Monthly Specification Update

Intel® Server Board S3420GP

Intel Order Number E82362-008

October 2011

6. Intel® Server Board S3420GP Quick Start User Guide update for the processor socket protective cover change

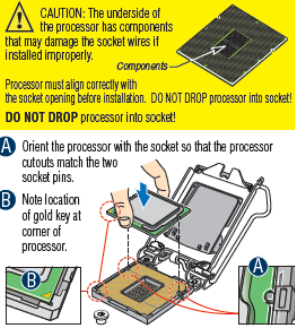
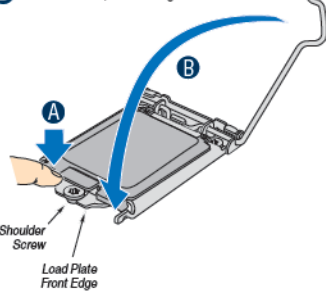
Implication To reflect the processor socket protective cover change, the following step will be the post-change installation procedure.
